PJM Interconnection, L.L.C.
Docket No. ER20-1446-000

Reference: Amended Interconnection Service Agreement

Re: *PJM Interconnection, L.L.C., Docket No. ER20-1446 -000 Amendment to ISA, SA No. 4541; Queue No. W1-124/AA2-049 (amend)*

CUSTOMER FACILITY LOCATION/SITE PLAN

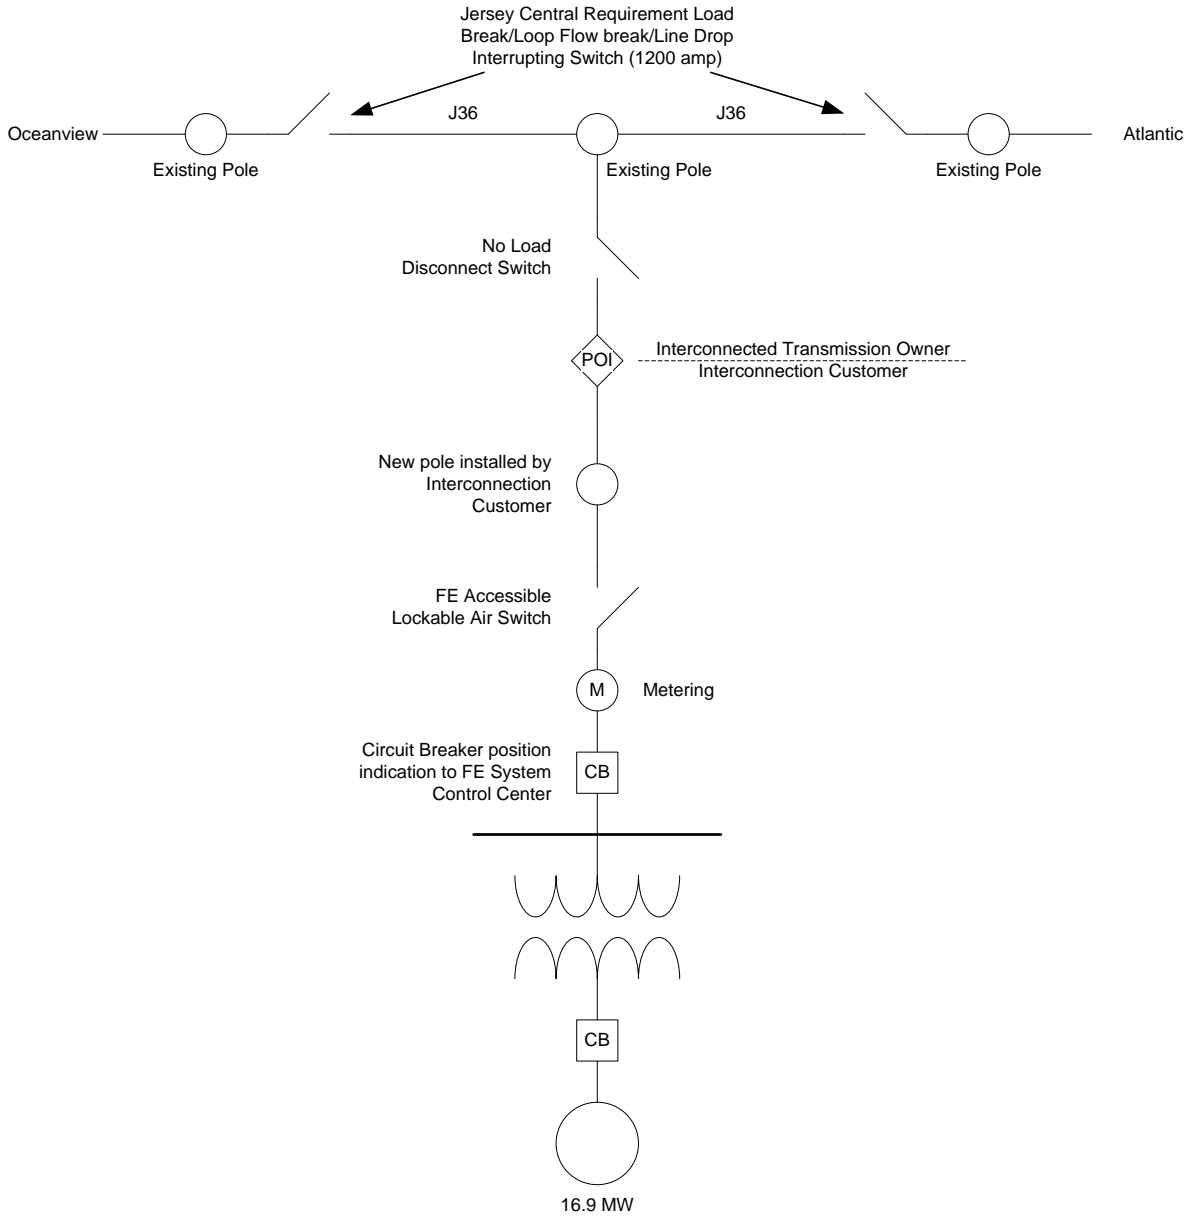
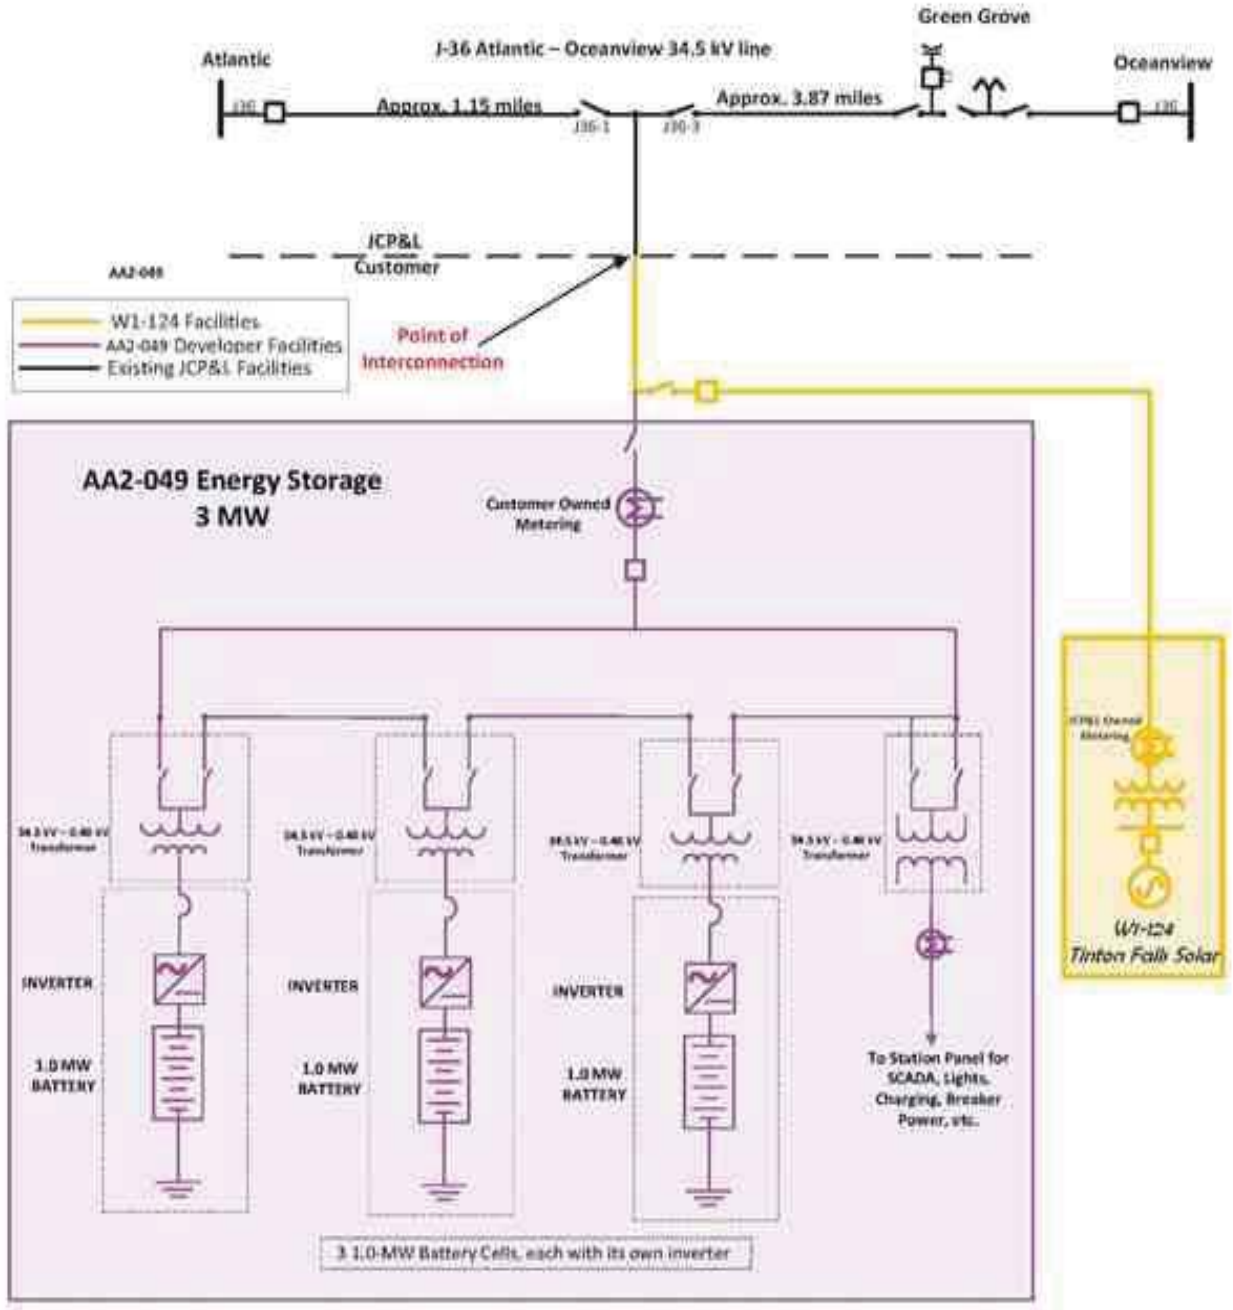
| Schedule A | Customer Facility Location/Site Plan for Queue #W2-124/AA2-049 Interconnection Requests. | Customer Facility Location/Site Plan for Queue #W2-124 Interconnection Request. |
